Fire Restoration
at
Ballinger Commons

ADDENDUM NO. 1

CONTRACT NUMBER: DW2403331

Unit 101 as shown on plans:

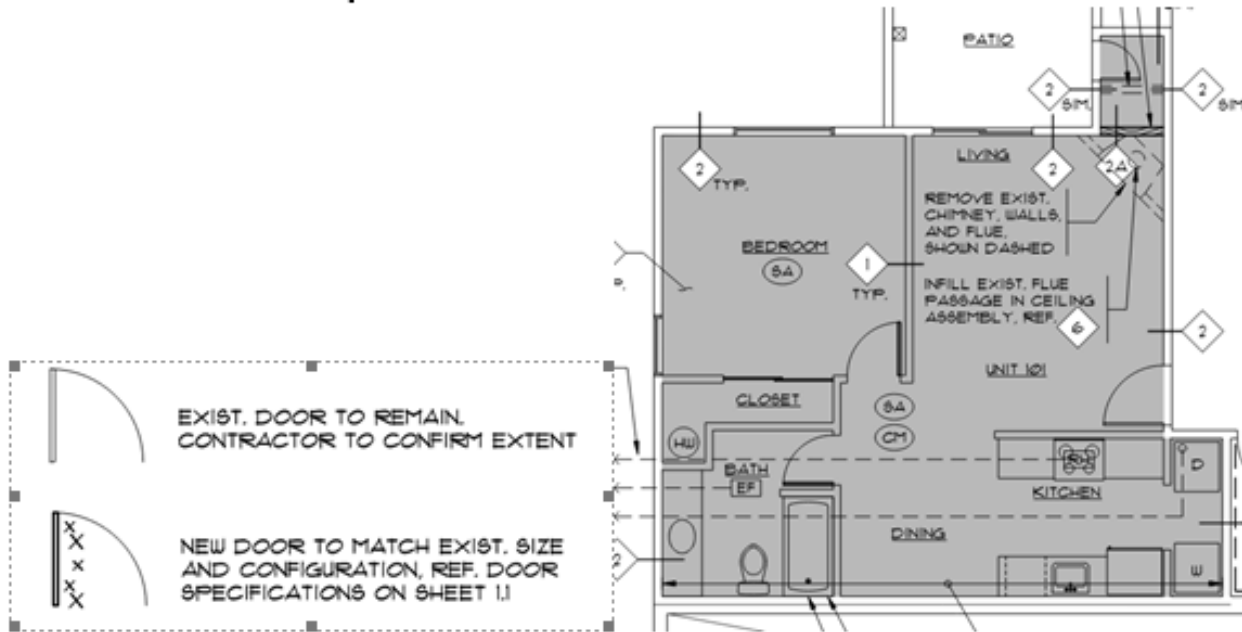
Q1: Plans have a legend to call out existing doors to remain and new door to match existing, however information in the specifications seems contradictory.

Per snips below no doors are to be replaced in unit 101, but per the spec pictured below a bifold door that is not pictured in the plans is asking to be removed and replaced.

Please confirm that the laundry bifold door is all that is to be replaced in unit 101.

A1: All damaged doors should be removed and replaced. Any existing doors should be reviewed by the contractor to determine if they are salvageable and then have a conversation between Contractor/Insurance/Client/Owner to decide whether or not to replace them. It is hard to tell in the snip below, but in the PDF the doors being replaced are bolder than the existing and we have assumed all the doors are being replaced within the affected units. We were not aware of a bi-fold door separating the kitchen/laundry closet.

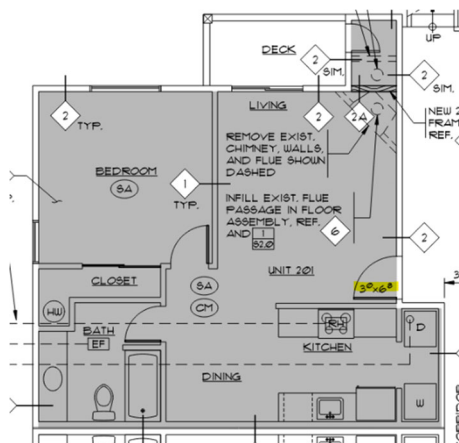
Q2: Multiple doors are called out in the specifications, however, the only door marked as remove and replace is the unit 101 laundry bifold. Per the plans it shows some unit entry doors as “New door to match existing” (pictured below). Please confirm what doors need replacing.

A2: See Item No. 1 comment. We know Unit 201 and 301 entry doors need to be replaced. We specifically call those out because they are exterior, and fire rated which require additional information for permit submittal.
